Poortjies Wind Energy Facility and associated infrastructure, Northern Cape Province

Motivation for amendment of Environmental Authorisation

DFFE Ref.: 14/12/16/3/3/2/681/1/AM1

October 2021

Figure 2.3: Poortjies proposed amendment (2021) showing turbine positions and associated infrastructures) (A3 Map included in Appendix I).

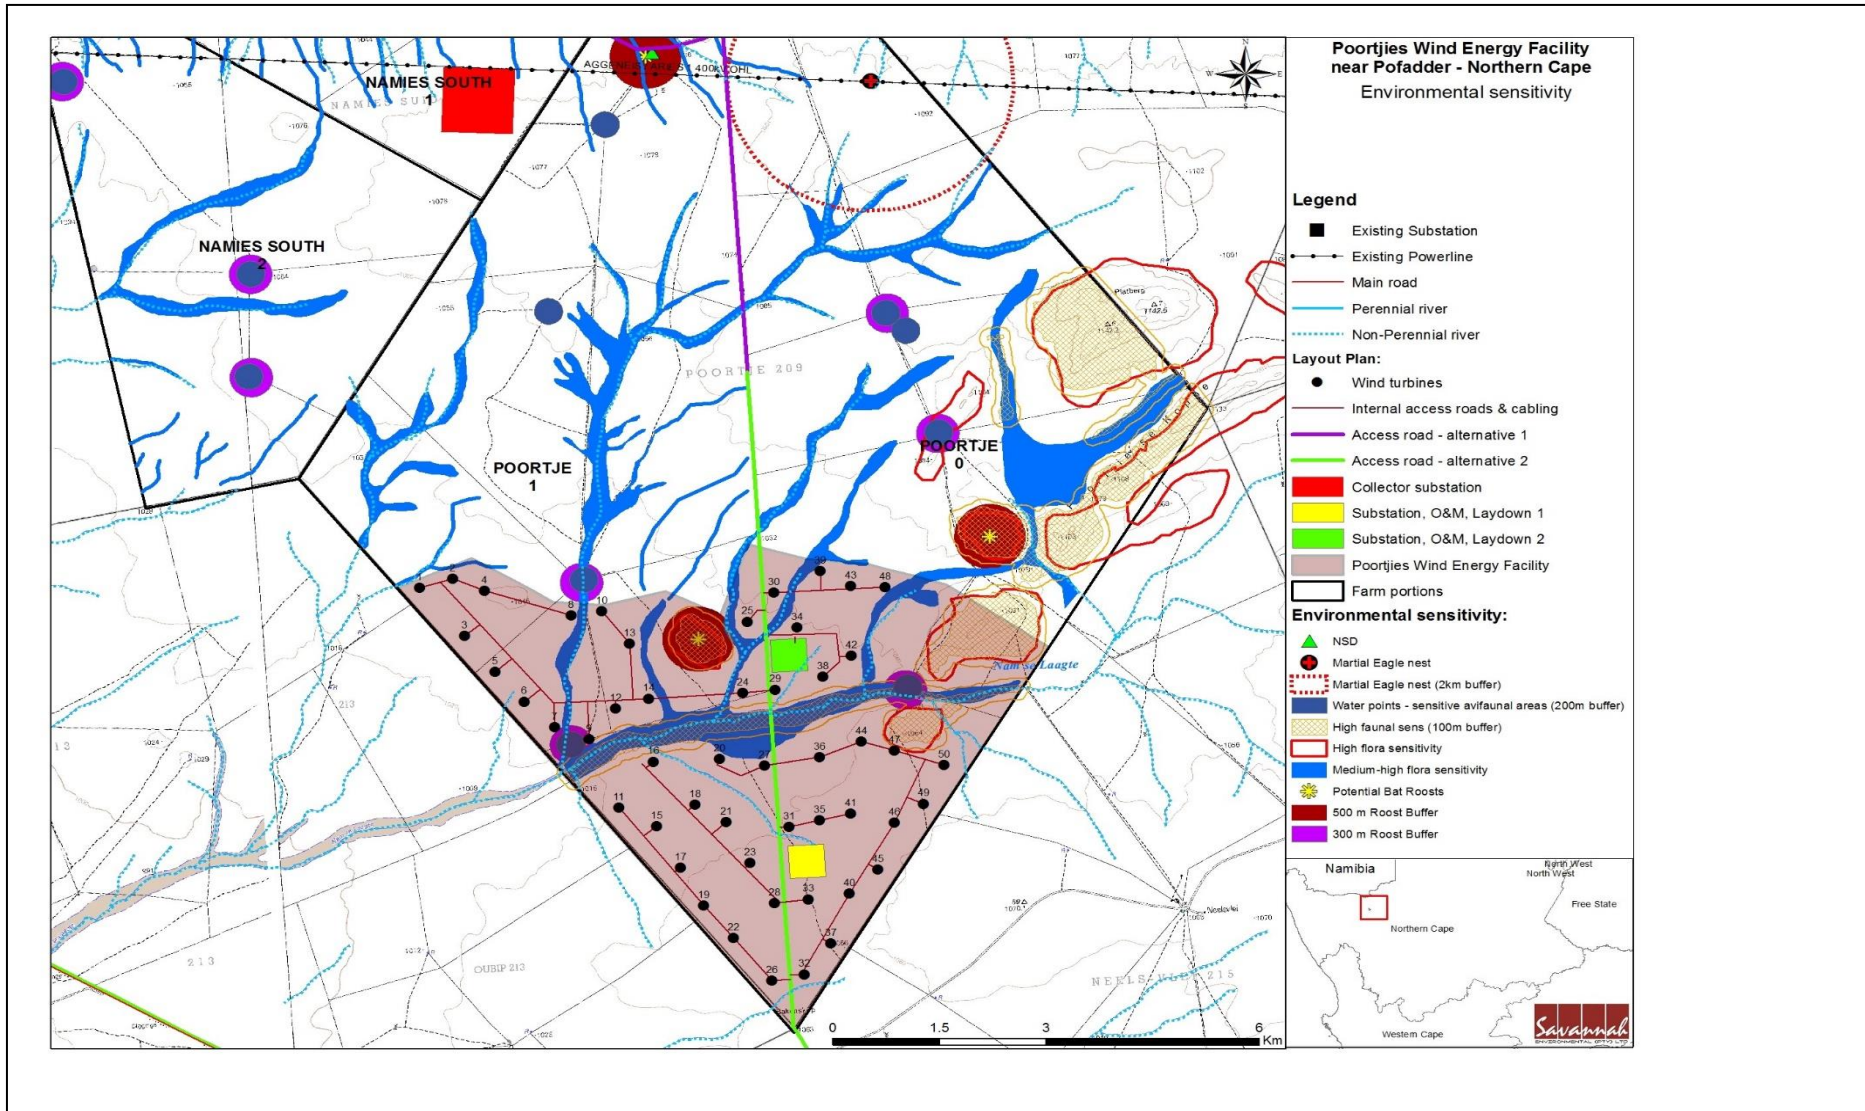
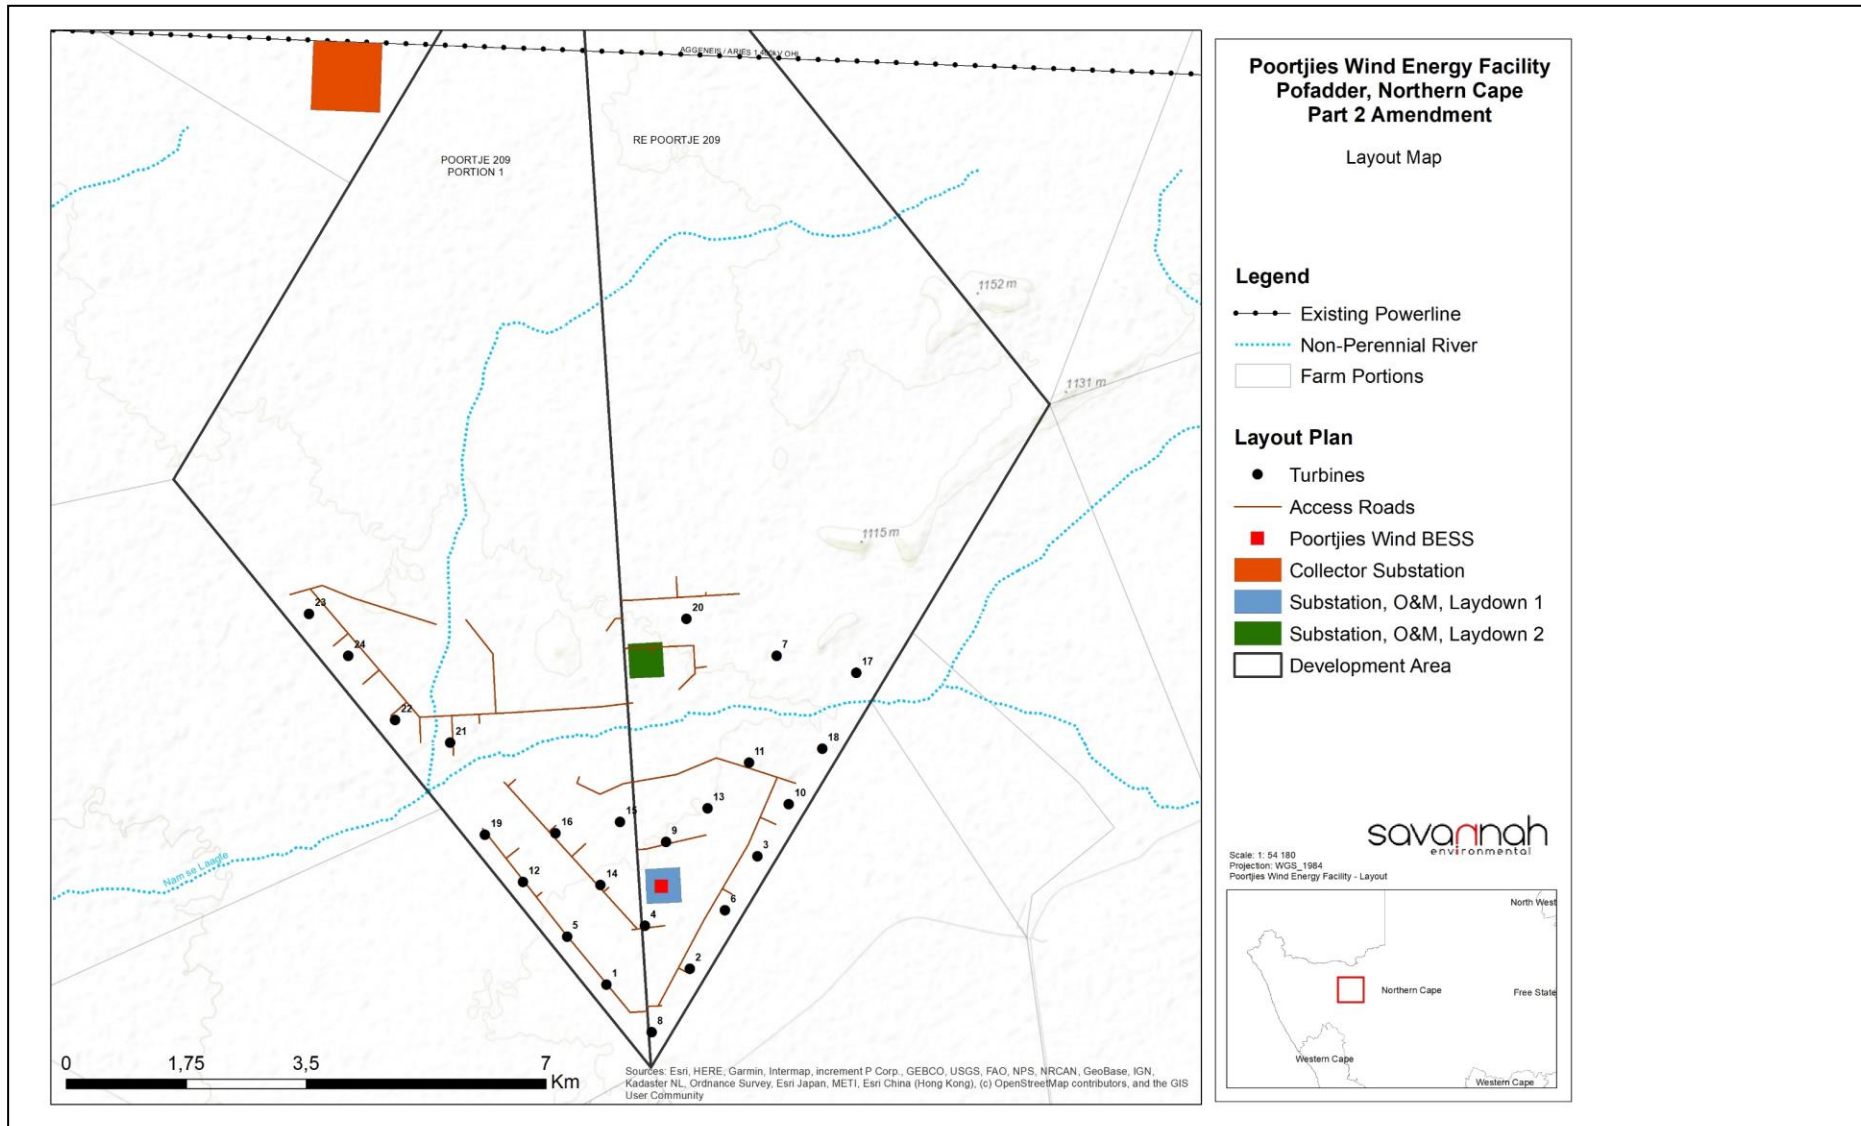
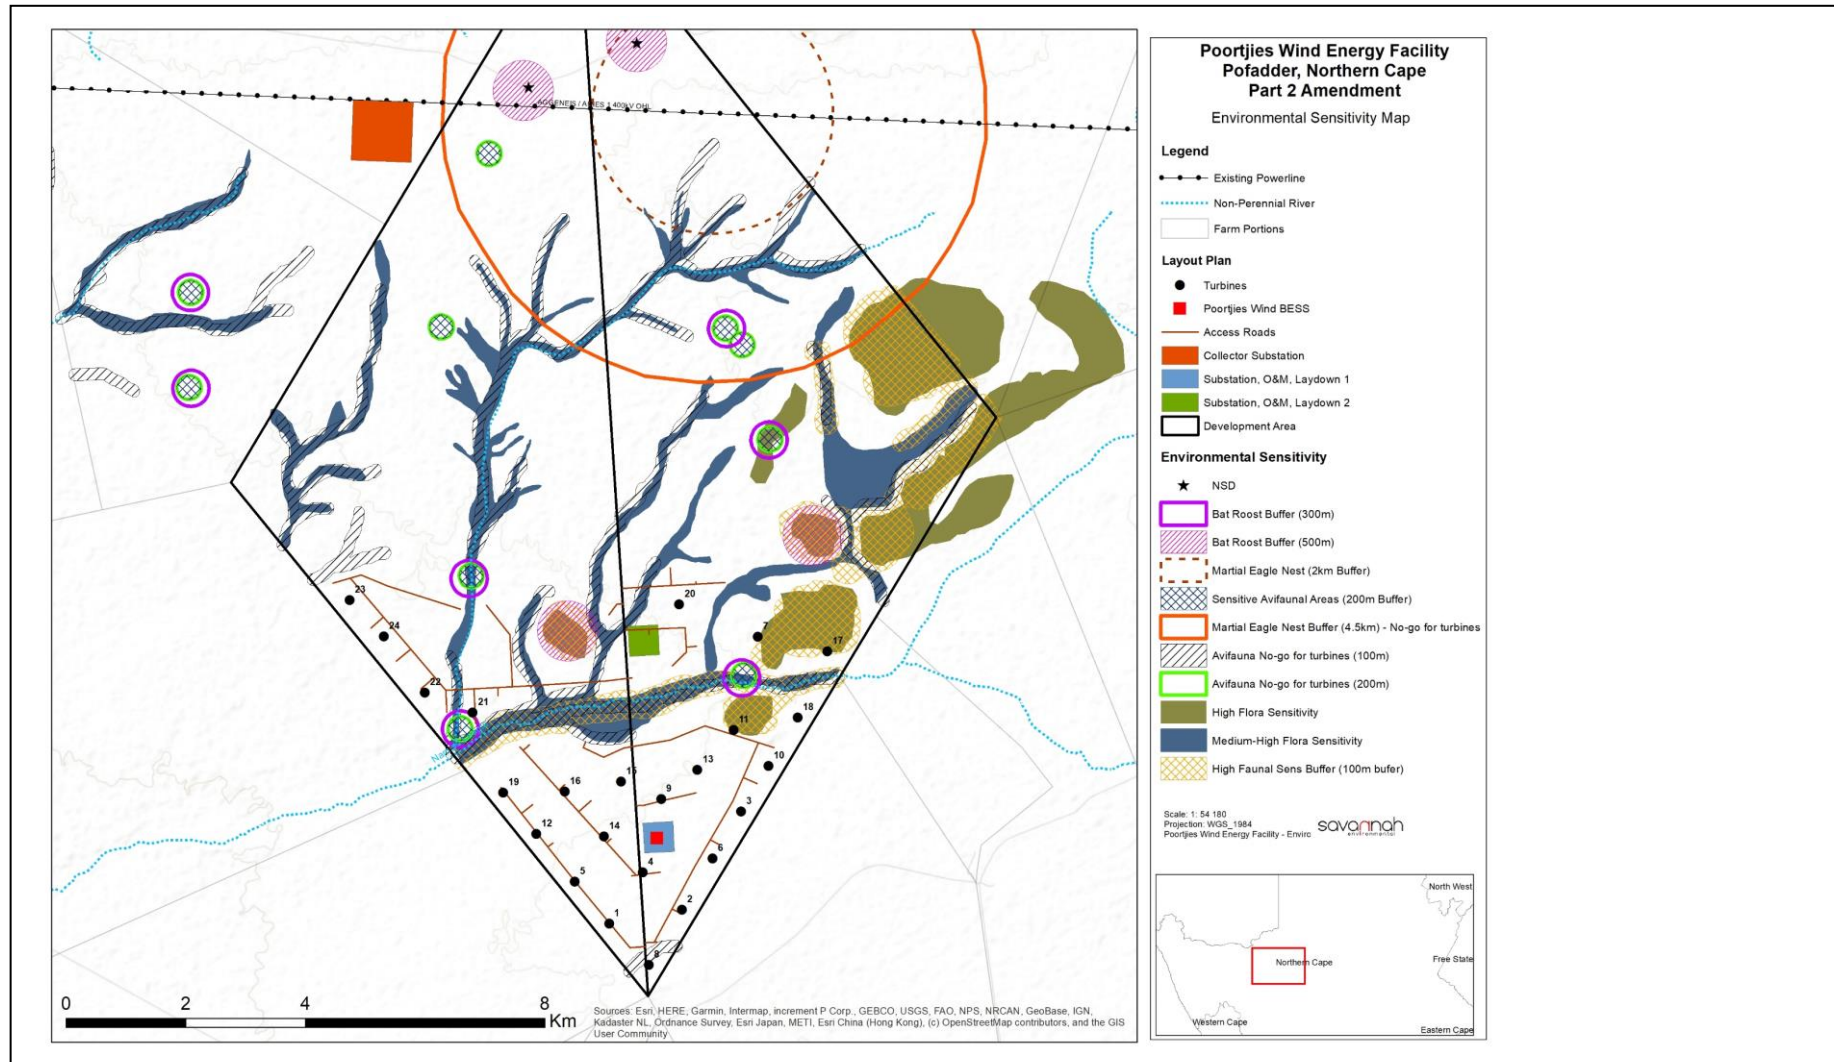
The number of wind turbines are proposed to be decreased from the currently authorised 50 turbines, to 24 turbines. It is therefore requested that the project description in the EA be amended to include the revised number of turbines.

The combined sensitivity map as submitted in the Final EIA Report (2014) is provided in Figure 2.1 and the combined sensitivity map as submitted in the Split EIA Report (2021) is provided in Figure 2.2. The proposed amended layout showing 24 turbines is provided in Figure 2.3 and its associated combined sensitivity in Figure 2.4.

layout. This layout is therefore submitted as part of the amendment to reflect 24 revised turbine positions for the proposed facility.

Figure 5.1: Comparative Viewshed Analysis for Poortjies Wind Farm

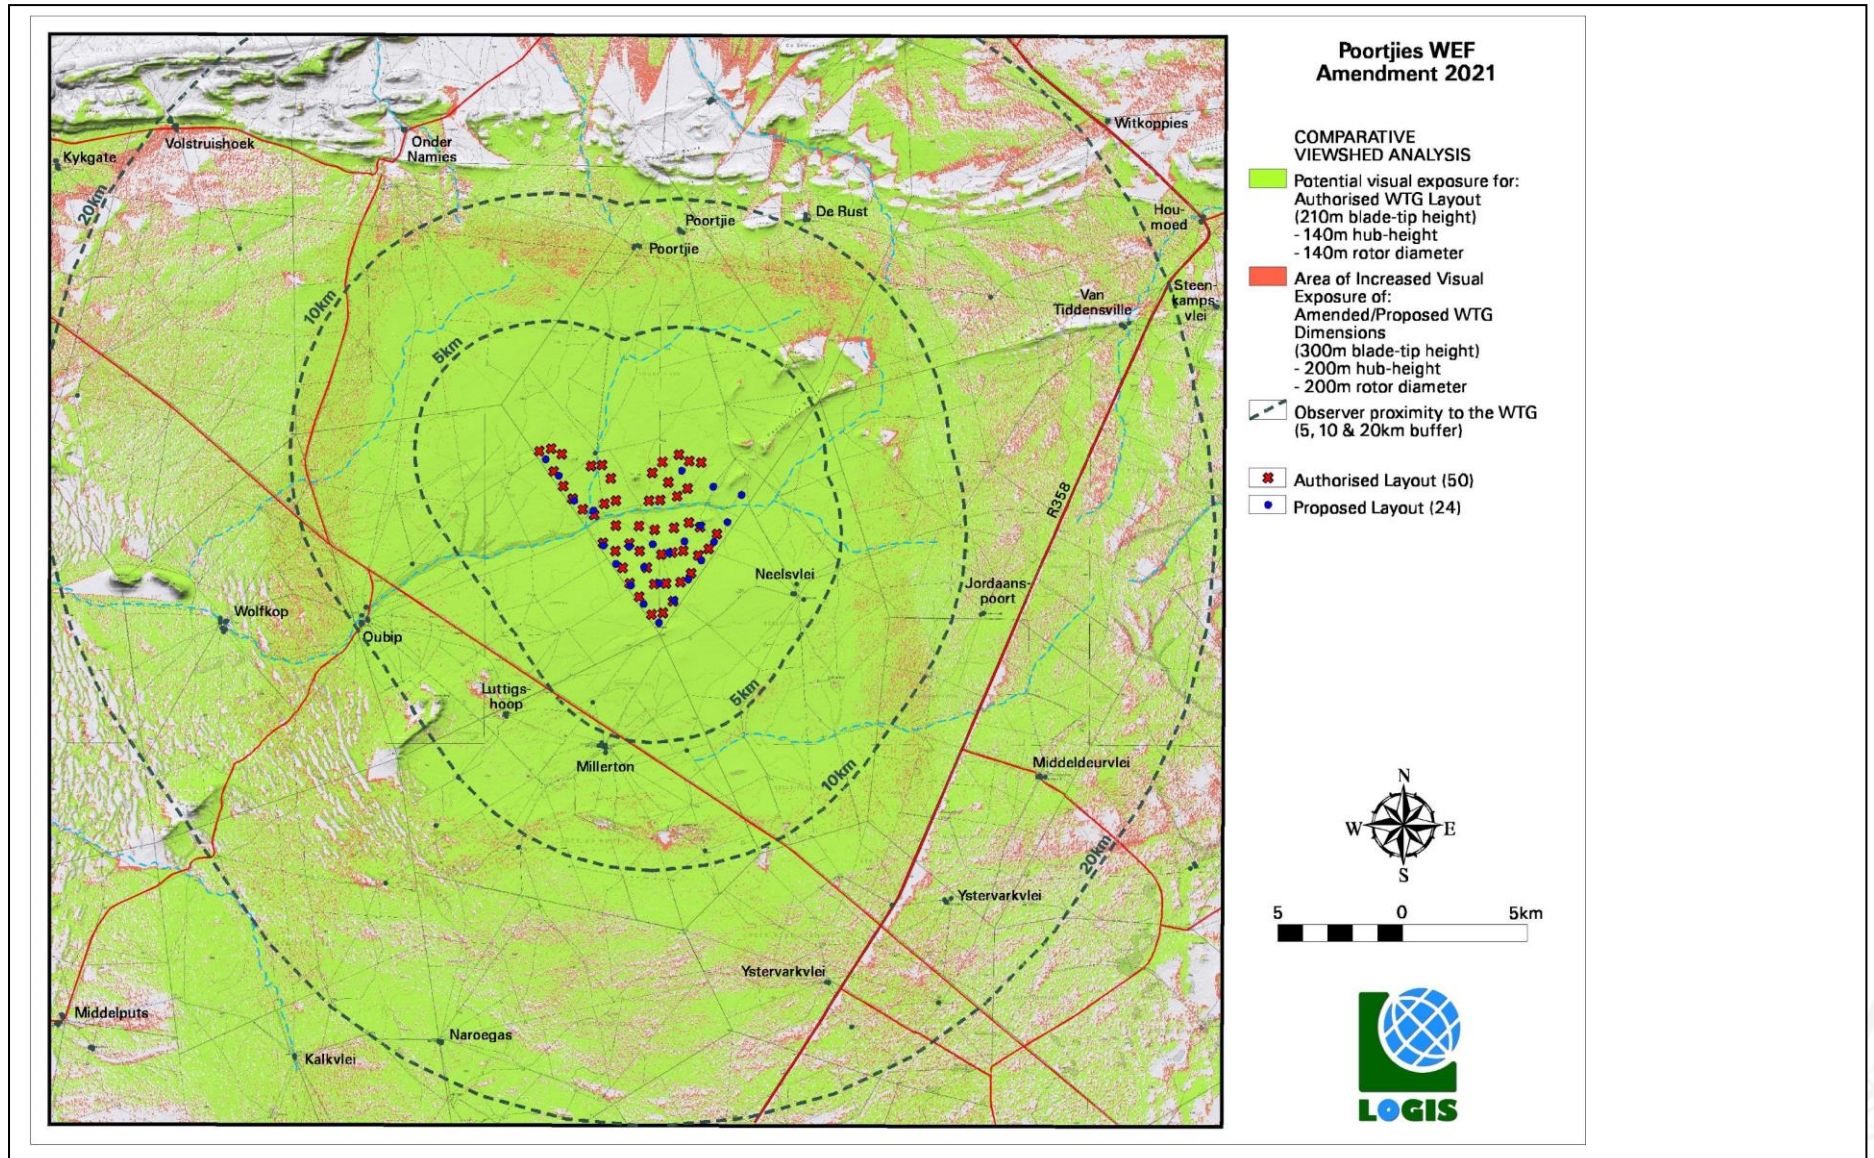
A viewshed analysis was undertaken (**Figure 5.1**) from each of the authorised wind turbine positions (50 in total) at an offset of 210m (maximum tip height) above ground level. The result of this analysis represents the potential total visual exposure of the original and authorised turbine dimensions (indicated in green on **Figure 5.1**). The viewshed analysis was repeated at an offset of 300m to indicate the visual exposure (shown in red) of the increased turbine dimensions (24 in total) proposed as part of the amendment. The results of the viewshed analyses are displayed on **Figure 5.1** overleaf.

The analysis indicated that with the proposed amendments, approximately 30% increase in turbine dimensions, would have a relatively small influence on the overall visual exposure of the wind farm, due to the already tall turbine structures previously authorised and the predominantly flat topography of the surrounding landscape. The surface area (within the study area) of the original turbine exposure is 1,264km², compared to the 1,467km² of the increased dimensions of the wind turbine exposure. This is an increase of 203km², or alternatively, an increase of 16% in the potential visual exposure.

In spite of the increase in the turbine dimensions it is expected that the wind turbine structures, both the original dimensions and the proposed increased dimensions would be equally visible and noticeable from both the roads and homesteads identified above. This signifies a negligible change to the potential visual impact with the implementation of the amended turbine dimensions. Therefore, no impact tables are presented here.
